HEALTH CARE CAPITAL  
 CONSOLIDATED, INC.  
 LOWER ROSSELL ROAD, COBB COUNTY, GA  
 LIND LOT# 1114, 1115, 1116 DISTRICT 2ND SECTION

ZONING  
 SUBMITTAL PLAN

ZN-100

**PETITION NO:** Z-41

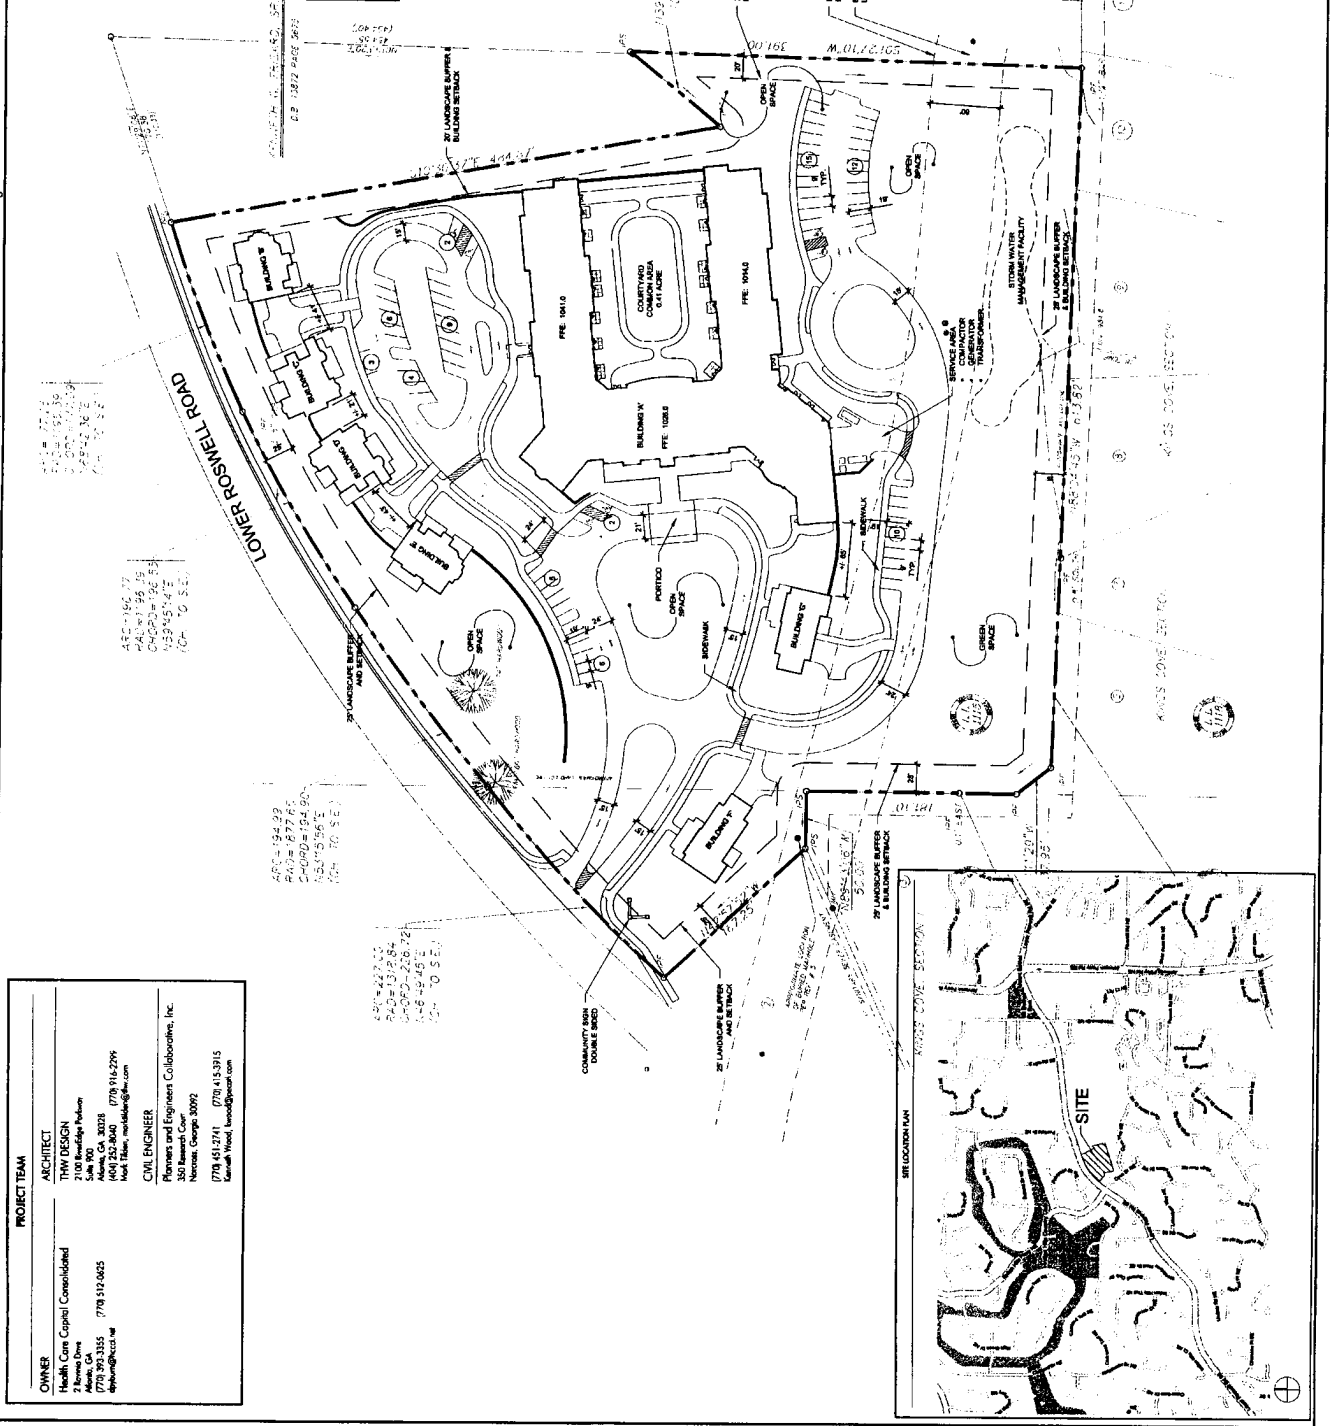
CCMWA requests to review the plans for this project as soon as they are available in order to determine the extent of impact upon our facilities. On Lower Roswell Road, backs up to CCMWA's Quarles WTP and the Authority has a 30" PCCP Transmission Water Line and a 60' Permanent Easement that runs through the proposed project. The owner/developer will be financially responsible for any impacts to CCMWA facilities from the project. Contact Chuck Byrge at (770) 426-8788 to coordinate plan review.

All access roads shall have an all weather driving surface capable of supporting 75,000 pounds with an unobstructed width of not less than 20 feet, 25 feet inside turning radius, 50 foot outside turning radius, and unobstructed vertical clearance of not less than 13 feet 6 inches.

Access road shall extend to within 150 feet of all portions of the facility or any portion of the exterior wall of the first floor.

Aerial apparatus access shall be required for all structures over 30 feet in height measured from the lowest level of fire department access to the ceiling height of the highest occupiable floor level. Aerial fire apparatus roads shall be a minimum width of 24 feet face of curb to face of curb maximum of 40 feet from the structure and be positioned parallel to the long side of the building for its entire length. No overhead utility and power lines shall be located within the aerial apparatus access.

Size / Location of Existing Water Main(s): **12" DI / S side Lower Roswell Rd**

Additional Comments: Master meter to be at entrance

Additional Comments: \*\*Connection to on-site sewer (W edge of property) may require private pump station, depending on site grading plan. Connection to Cove Way would required easements and possible sewer flow study.

- Provide comprehensive hydrology/stormwater controls to include development of out parcels.
- Submit all proposed site improvements to Plan Review.
- Any **spring activity** uncovered must be addressed by a qualified geotechnical engineer (PE).
- Structural fill \_\_\_\_\_ must be placed under the direction of a qualified registered Georgia geotechnical engineer (PE).
- Existing facility.
- Project must comply with the Water Quality requirements of the CWA-NPDES-NPS Permit and County Water Quality Ordinance.
- Water Quality/Quantity contributions of the existing lake/pond on site must be continued as baseline conditions into proposed project.
- Calculate and provide % impervious of project site.
- Revisit design; reduce pavement area to reduce runoff and pollution.

- No Stormwater controls shown \_\_\_\_\_
- Copy of survey is not current - Additional comments may be forthcoming when current site conditions are exposed.
- No site improvements showing on exhibit.

1. The extensive existing tree stand and undergrowth provide significant air/water quality, soil stabilization and storm flow mitigation benefits for this watershed. Construction of this project will eliminate the vast majority of this vegetation and increase pavement, storm runoff and non-point source pollution. To compensate, the First Flush Water Quality Best Management Practice Requirements must be elevated to the 1.5-inch rainfall event and each larger storm discharge controlled not to exceed the allowable discharge of the next lower, more frequent storm event (ie. 5-year storm event released at 2-year rate; 10-year event at 5-year rate; etc. to 100-year event at 50-year rate).

2. As indicated under downstream conditions, there is an existing lake located approximately 900 feet downstream. Elevated erosion & sediment control measures will be required to protect this lake. A pre- and post-development sediment survey will also be required to document any impact to the lake.

3. The proposed site discharges to the south through an existing channel located on single-family residential lots. The site discharge should be directly connected to the existing downstream culvert at Cove Way to eliminate potential problems associated with this short open channel.

Lower Roswell Road is classified as an arterial and according to the available information; the existing right-of-way does not meet the minimum requirements for this classification. Recommend applicant consider entering into a development agreement pursuant of O.C.G.A. 36-71-13 for dedication of the following system improvements to mitigate traffic concerns: a) donation of right-of-way on the south side of Lower Roswell Road, a minimum of 50' from the roadway centerline.

Recommend a deceleration lane on Lower Roswell Road.
